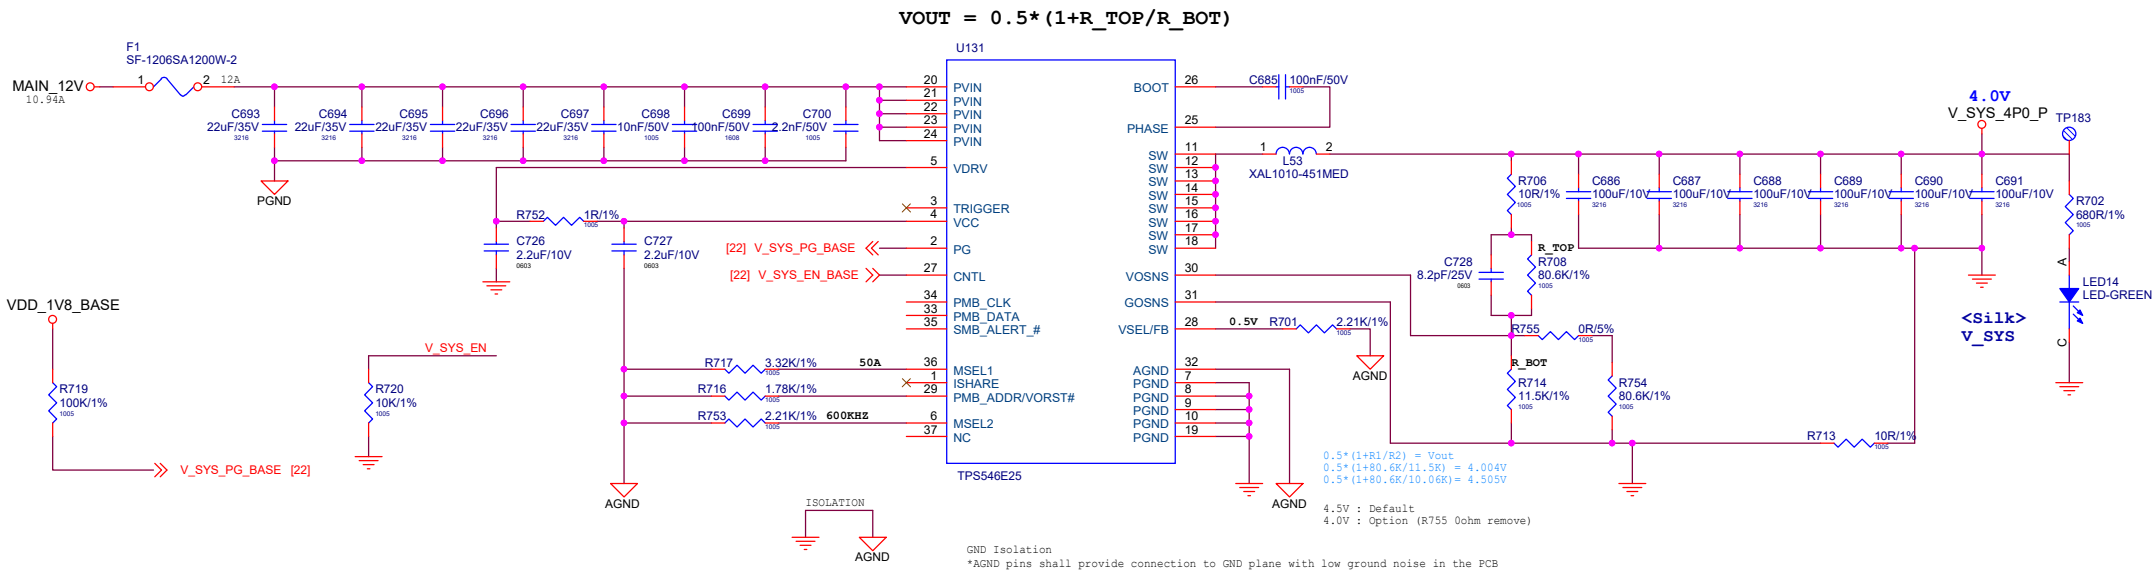
See simple example schematic for
external divider option
R717 MSEL1 should be 26.7ohm for ext. div.

node between Rbot and Rtop should
connect to VSEL/FB
change Rbot and Rtop using 0.4V as VREF
vosns to vout through 10ohm

webench is available from ti.com product folder
